**ADDENDUM # 02**

RE: CHANGES TO PROJECT MANUAL AND DRAWINGS DATED JUNE 6, 2022

DATE: JULY 25, 2022

SUBJECT: COLUMBIA HOUSING AUTHORITY  
COLUMBIA, SC  
ARCHITECT PROJECT #20-12740

Sheet No.: A100

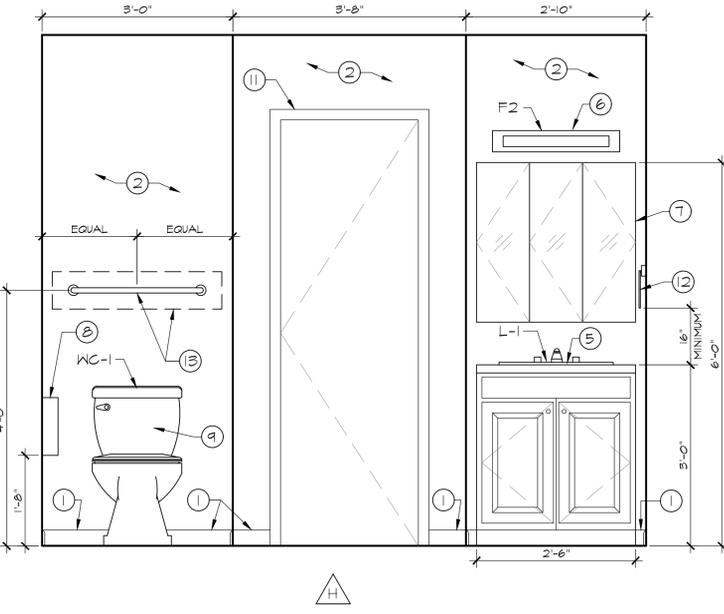
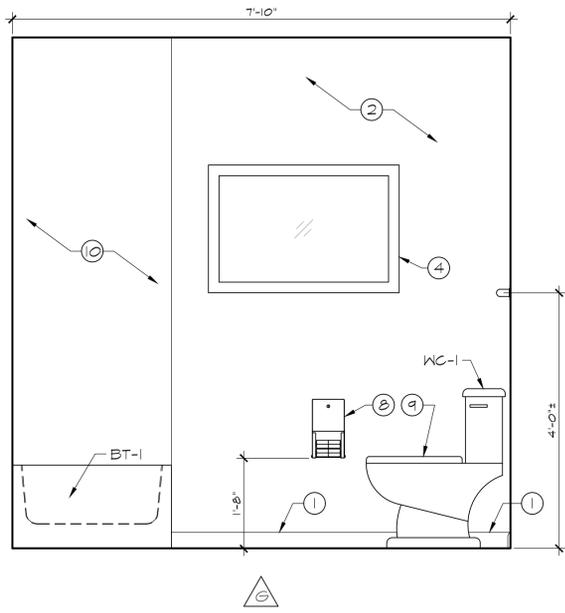
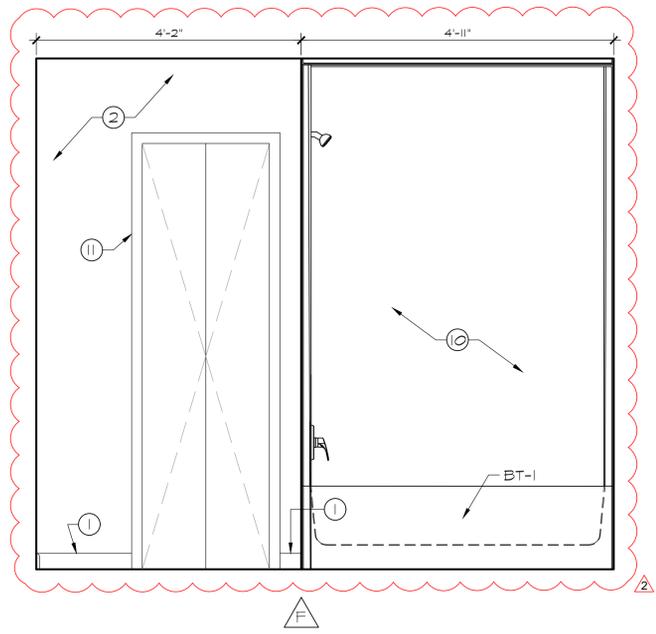
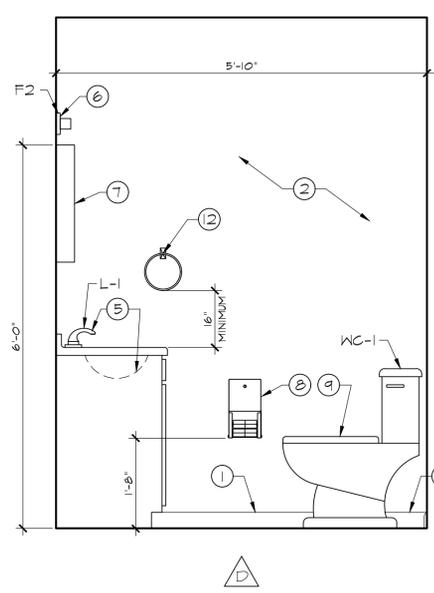
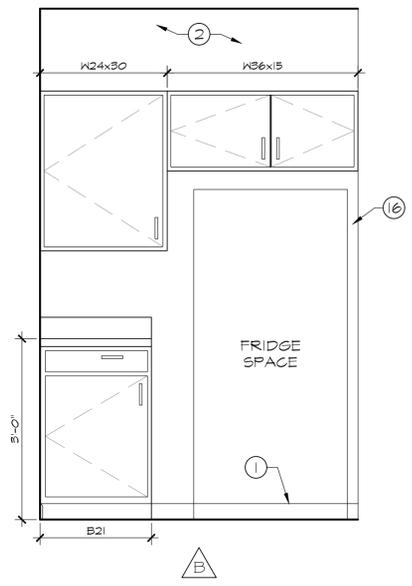
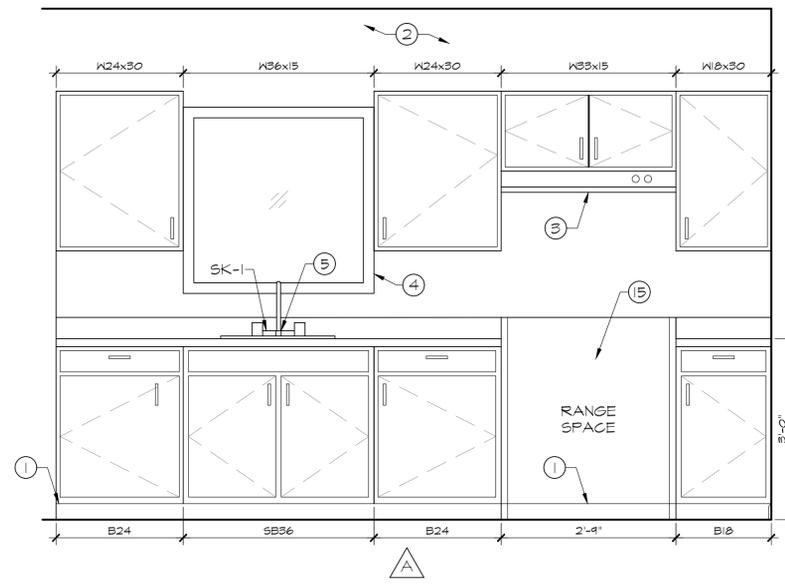
3. Q: "Only 1 Tub per household – Change master tub to walk in shower."  
A: Tubs that apply have been changed to walk-in shower on unit plan sheets as well as corresponding interior elevation sheets.

5. Q: "All doors must be hinged"  
A: Unit plan Bi-Fold doors have been changed to hinged doors. See attached unit plans.
6. Q: "Are we replacing door hardware?"  
A: Yes (except most of Rosewood homes) see attached revised floor plans and door schedule.

7. Q: "Do we have anything with replacing washer and dryer connections and installing new dryer vents?"  
A: Yes, these connections will be new only at unit(s) where the floor is being raised at. See attached unit plans.
